Rezoning Transportation Analysis

Petition Number: 2024-129

Date	Description
11-26-24	First Review (CM)
12-23-24	Second Review (CM)
07-24-25	Third Review (CM)
08-20-25	Fourth Review (CM)
10-23-25	Fifth Review (CM)
11-14-25	Sixth Review (TP)
11-24-25	Seventh Review (CM)

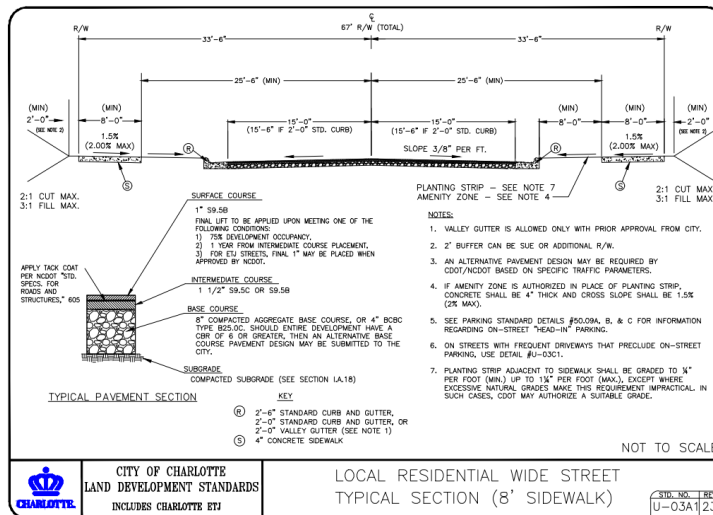
1. Curblines:

- ~~South Tryon Street:~~ curb relocation is required to 42.5' from the centerline to back of curb for a 4+ Avenue, Buffered/Separated Bike Lanes, On-Street Parking is required.

- ~~Remount Road:~~ future back of curb location is 27' from the centerline for a 2+ Avenue, Buffered/Separated Bike Lanes. Existing curb and gutter is located in the future location.

- ~~Future Street A:~~ to be built to residential wide typical section U-03A-1.
- ~~Future Street B:~~ to be built to residential wide typical section U-03A-1.

- ~~Future Street Extension C:~~ to be built to residential wide typical section U-03A-1.
- ~~Future Street D:~~ to be built to residential wide typical section U-03A-1.

- ~~Brookhill Road:~~ Location of future back of curb is 17.5' from the centerline for a residential wide typical section. Show future back of curb location on site plan.

- ~~Remus Road:~~ Location of future back of curb is 17.5' from the centerline for a residential wide typical section. Show future back of curb location on site plan.

- ~~Basin Street:~~ Location of future back of curb is 17.5' from the centerline for a residential wide typical section. Show future back of curb location on site plan.

- ~~Village Court:~~ Location of future back of curb is 17.5' from the centerline for a residential wide typical section. Show future back of curb location on site plan.

Label and dimension the curb and gutter from the centerline for each road on the site plan.

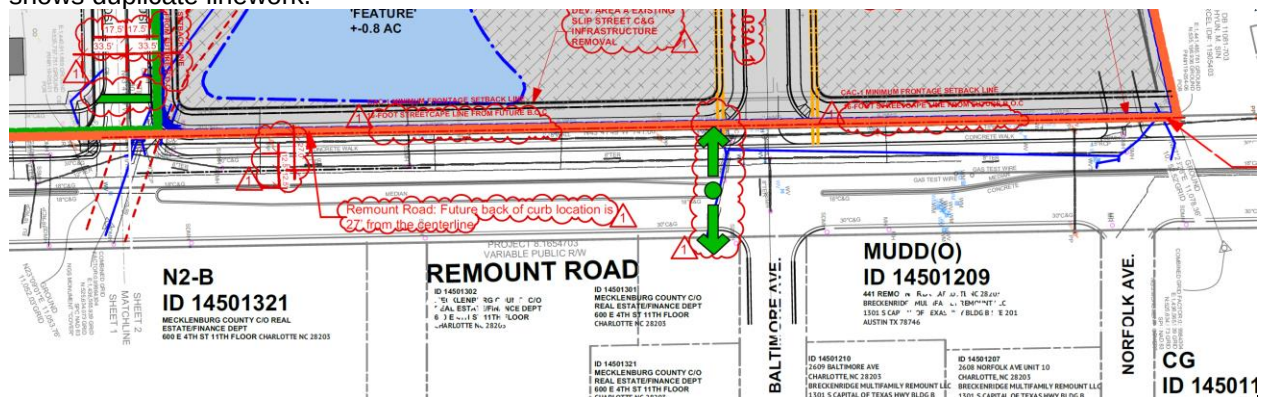
8. ~~Revise conditional Transportation note V.d to “the Petitioner shall dedicate and convey in fee simple all rights of way to the City before the site’s first building certificate of occupancy is issued. CDOT requests rights of way set at 2’ behind back of sidewalk where feasible.”~~

~~Clarifying Comment 12.23.24: Replace note V.h with language above. Remove reference to phasing.~~

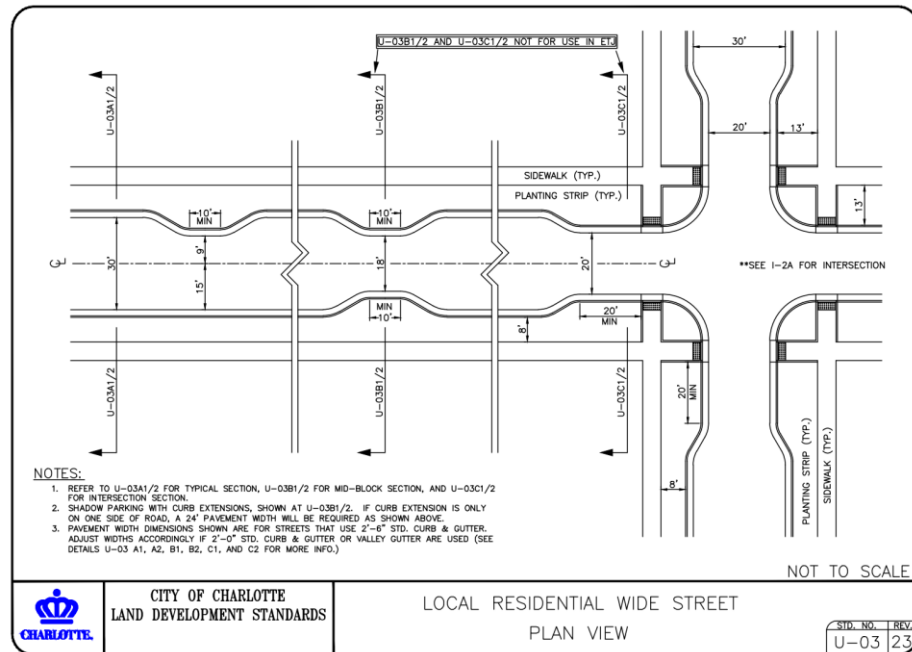
12. **New Comment 7.24.25:** Remove Notes H.2.a, H.2.b, H.3.d, H.7.b

Outstanding Comment 8.20.25: Remove Notes I.2.a, I.2.b, I.3.d, I.7.b

Outstanding Comment 10.23.25: Remove Notes I.3.a, I.3.b, I.4.d, I.8.b

Clarifying Comment 11.24.25: Remove Notes I.3.a, I.4.d, I.8.b. Parking standards will follow current CLDSM standards and all events will be coordinated with CDOT events team for any event and/or road closures.
